# Access Compliance Report

## Public Rights-of-Way

Intersection ID: 2745	Main Street: HIGHLAND_CREEK_PY	Cross Street: SHELLEY_AV	Location:	N
ADA ID: 15EA10B7B73A	Ramp Type: BlendTrans1	Initial Pass/Fail: Fail	Overall Compliance: No	Severity Score: 1.25

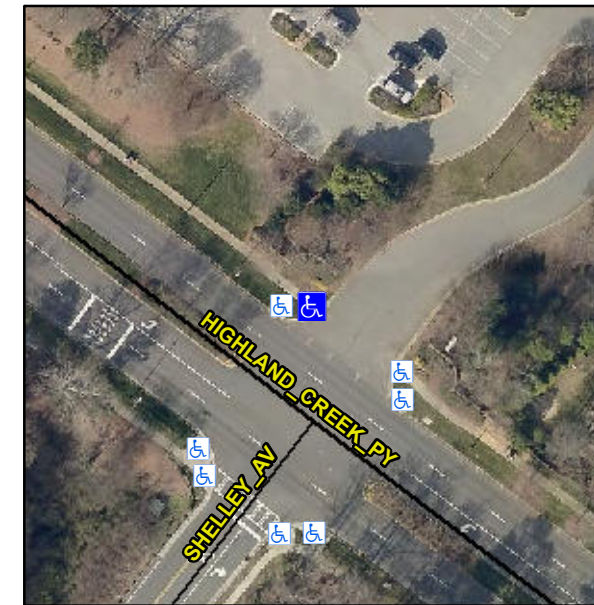
**Not Found, R304.5.3**

Compliance	Description	Data	Compliance	Description	Data
N/A	Ramp Length (in)	78.0	Yes	BlendTrans Slope (%)	1.6
Yes	Ramp Width (in)	61.0	No	BlendTrans XSlope (%)	3.6
N/A	Flare Type LT	N/A	N/A	Flare Type RT	N/A
N/A	Flare Slope LT (%)	N/A	N/A	Flare Slope RT (%)	N/A
N/A	Flare Traversable LT?	N/A	N/A	Flare Traversable RT?	N/A
N/A	Landing Length (in)	N/A	N/A	DWS Provided?	N/A
N/A	Landing Width (in)	N/A	N/A	DWS Contrast?	N/A
N/A	Landing Slope (%)	N/A	N/A	DWS Length (in)	N/A
N/A	Landing X Slope (%)	N/A	N/A	DWS Full Width?	N/A
N/A	Landing Curb? (Y/N)	N/A	N/A	DWS Offset (in)	N/A
N/A	Shared Landing?	N/A			
N/A	Gutter Ponding?	N/A	N/A	Gutter Slope (%)	N/A
N/A	Gutter Lip Ht (in)	N/A	N/A	Gutter X Slope (%)	N/A
N/A	Painted X Walk1?	No	N/A	Painted X Walk2?	N/A
	X Walk 1 Direction	To SE		X Walk 2 Direction	N/A
	X Walk 1 Width (in)	N/A		X Walk 2 Width (in)	N/A
	X Walk 1 Slope (%)	4.4		X Walk 2 Slope (%)	N/A
	X Walk 1 X Slope (%)	3.1		X Walk 2 X Slope (%)	N/A

N/A	Ramp inside XWalk1?	N/A	N/A	Ramp inside XWalk2?	N/A
	Road Slope (%)	3.1		Clear Space?	N/A
	Road X Slope (%)	4.4	N/A	Clear Space to XWalk (in)	N/A
N/A	Any Obstructions?	N/A	N/A	Storm Grate/Utility Hazard?	N/A
	Obstruction Type			Storm Grate/Utility Type	
		N/A			N/A
			Yes	Surface Condition? (G/P)	Good
			No	Curb Slope (%)	10.4

**Remove & Replace Curb Ramp With Two New Directional Ramps or Equivalent.**
